Technical change to 3 to 5-pole unshielded M12 cord sets

The 3 to 5-pole unshielded M12 cord sets are lead-free in accordance with ROHS requirements, without the exception 6c. The changeover to the new design is carried out on the article number. Please forward this product change notice (PCN) to your employees and, if applicable, to your customers.

Old design		New design	
M12 socket straight

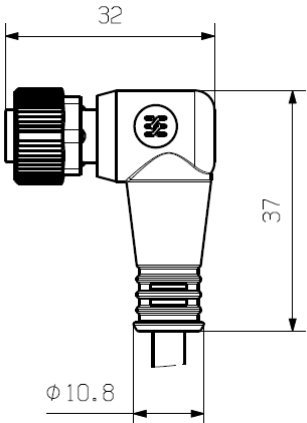
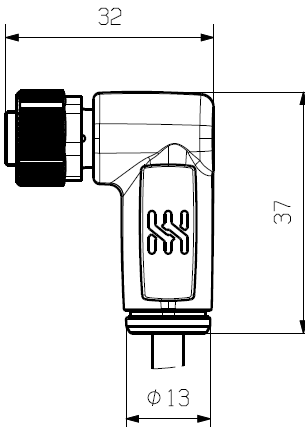
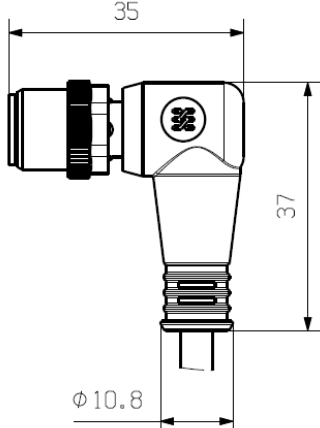
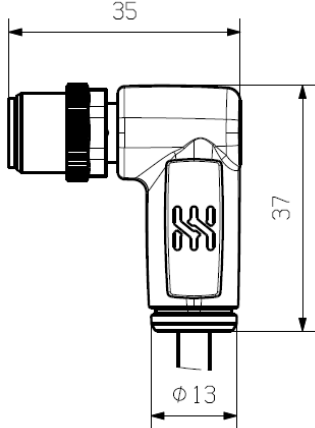
Until now, lead-containing materials were used for some components of the affected articles. As part of the changeover, these will be converted to lead-free materials so that the products in the new design comply with the RoHS Directive without the exception 6c. The new design changes the dimensions of the protective tube adapter from 10.8 to 13.0 mm. The maximum dimensions of the connector and the technical specifications remain unchanged.
